# Access Compliance Report Public Rights-of-Way (Curb Ramps)

**Main Street:** HYDE\_PARK\_DR      **Cross Street:** WICKFORD\_DR      **Location:** SW

**ADA ID:** RPRK211013112626      **Ramp Type:** Type 1 - Perpendicular Diagonal Initial Pass/Fail: Fail      **Overall Compliance:** No      **Severity Score:** 2

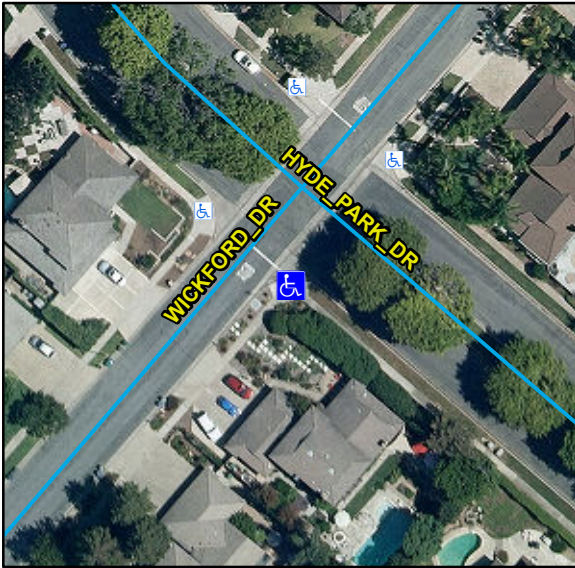
Compliance	Description	Data	Compliance	Description	Data
N/A	Ramp Length (in)	121	N/A	Flare Type LT	
Yes	Ramp Width (in)	48			N/A
Yes	Ramp Run Slope (%)	7.6	N/A	Flare Slope LT (%)	N/A
No	Ramp Cross Slope (%)	3.7	N/A	Flare Traversable LT	N/A
N/A	Landing Present	N/A	N/A	Flare Type RT	
N/A	Landing Length (in)	N/A			N/A
N/A	Landing Width (in)	N/A	N/A	Flare Slope RT (%)	N/A
N/A	Landing Run Slope (%)	N/A	N/A	Flare Traversable RT	N/A
N/A	Landing Cross Slope (%)	N/A	N/A	DWS Provided	N/A
N/A	Landing Movement Obstructed?	N/A	N/A	DWS Contrast	N/A
	Landing Movement Type	N/A	N/A	DWS Length (in)	N/A
N/A	Landing Shared	N/A	N/A	DWS Full Width	N/A
N/A	Clear Space	Yes	N/A	DWS Offset Left (in)	N/A
N/A	Clear Space To Crosswalk (in)	N/A	N/A	DWS Offset Right (in)	N/A
N/A	Marked Crosswalk 1	No	N/A	Marked Crosswalk 2	No
	Crossing 1 Direction	NE		Crossing 2 Direction	NW
	Marked Crosswalk 1 Width (in)	N/A		Marked Crosswalk 2 Width (in)	N/A

N/A	Ramp Inside Crosswalk 1	N/A	Yes	Ramp Inside Crosswalk 2	N/A
	Crossing 1 Slope (%)	5		Crossing 2 Slope (%)	3.5
	Crossing 1 Cross Slope (%)	6.6		Crossing 2 Cross Slope (%)	4.2
N/A	Gutter Ponding	N/A	No	Curb Slope	7.9
Yes	Gutter Lip Height (in)	0		Road Run Slope (%)	2.3
N/A	Gutter Run Slope (%)	N/A		Road Cross Slope (%)	5.8
N/A	Gutter Cross Slope (%)	N/A			
Yes	Overall Surface Condition: <b>Acceptable</b>		Yes	Perp Joint Present	Yes
	Cross Gutter Present?	Yes		Spandrel Present?	Yes
	Replace Cross Gutter?	No		Replace Spandrel?	No

**Possible Solutions:**  
**Remove & Replace Curb Ramp With Two New Directional Ramps or Equivalent.**
